SERVICE BULLETIN

2.062 Sq. In. and 4.125 Sq. In. Motor Changes

MODELS AFFECTED: 67147, 67314 and 67325

BULLETIN: #2-06

OLD MOTOR - 4.125 Sq. Inch

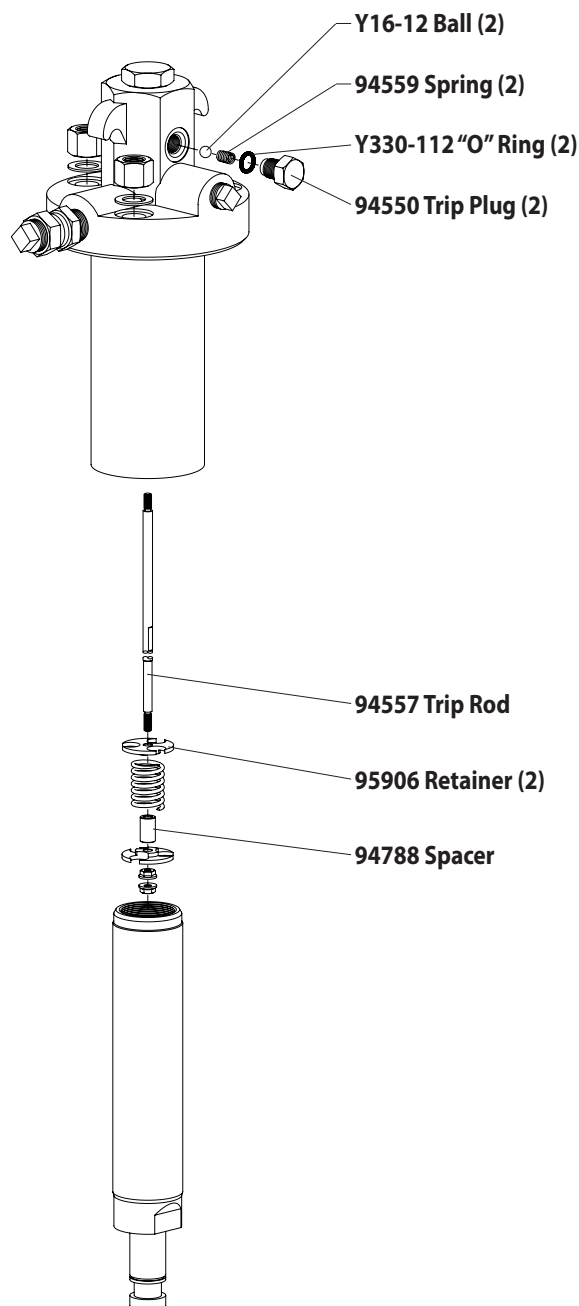
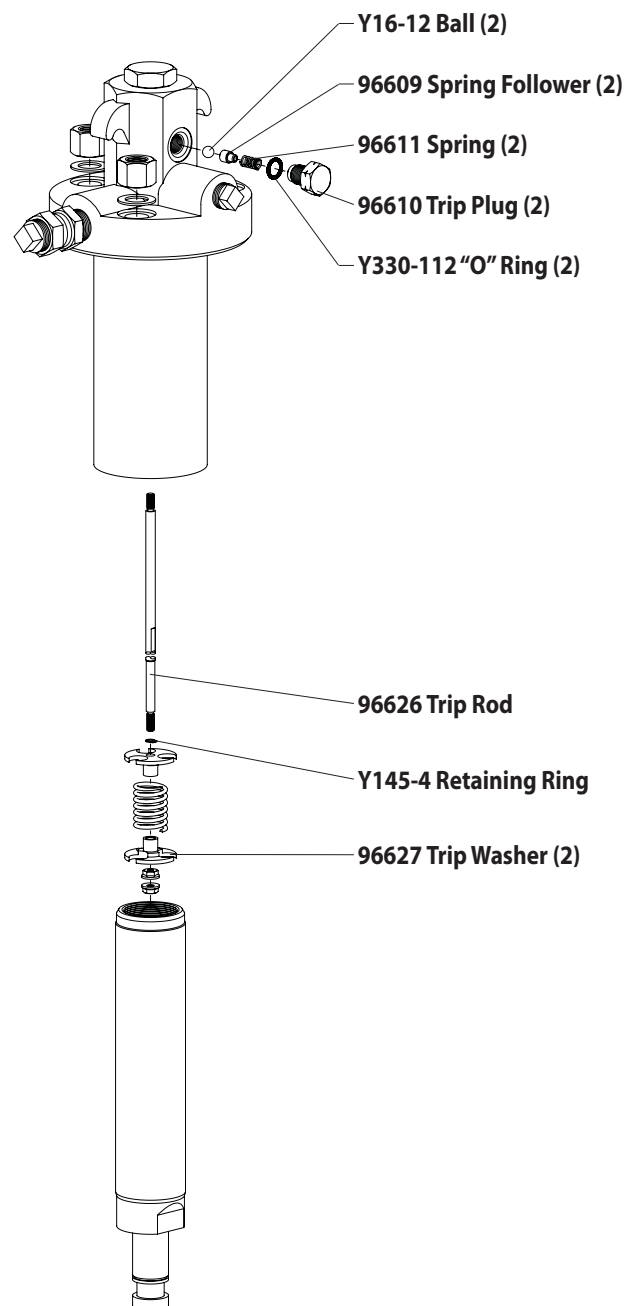
1. 94559 springs replaced by 96611 springs.
2. Add 96609 spring followers.
3. 94550 trip plugs replaced by 96610 trip plugs.
4. 94557 trip rod replaced by 96626 trip rod.
5. Add Y145-4 retaining ring.
6. 95906 retainers replaced by 96627 trip washers.
7. Remove 94788 spacer.

OLD MOTOR - 2.062 Sq. Inch

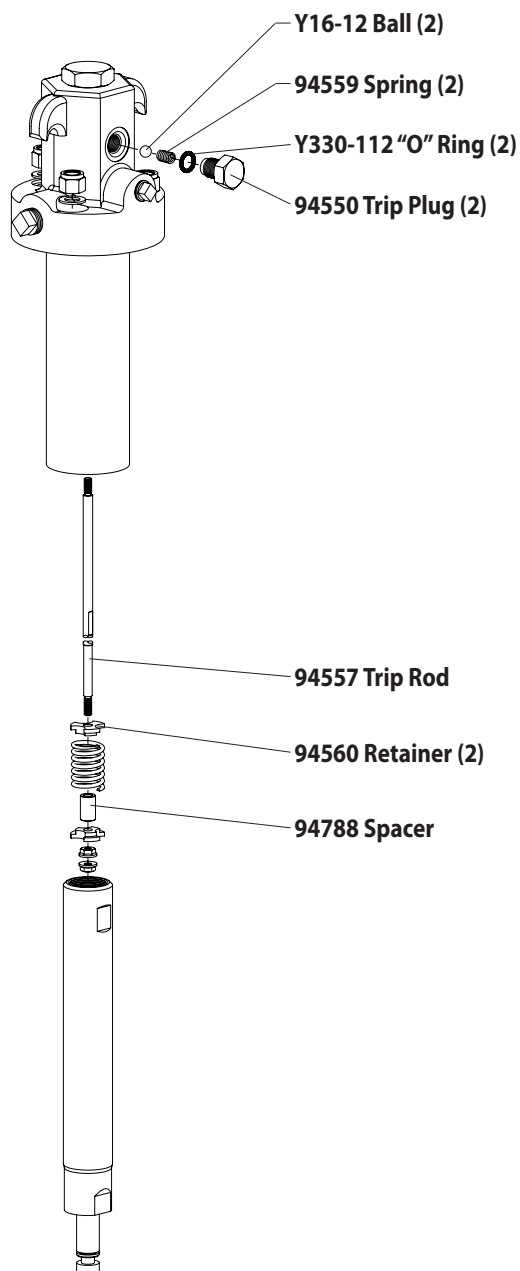
1. 94559 springs replaced by 96611 springs.
2. Add 96609 spring followers.
3. 94550 trip plugs replaced by 96610 trip plugs.
4. 94557 trip rod replaced by 96626 trip rod.
5. Add Y145-4 retaining ring.
6. 94560 retainers replaced by 96628 trip washers.
7. Remove 94788 spacer.
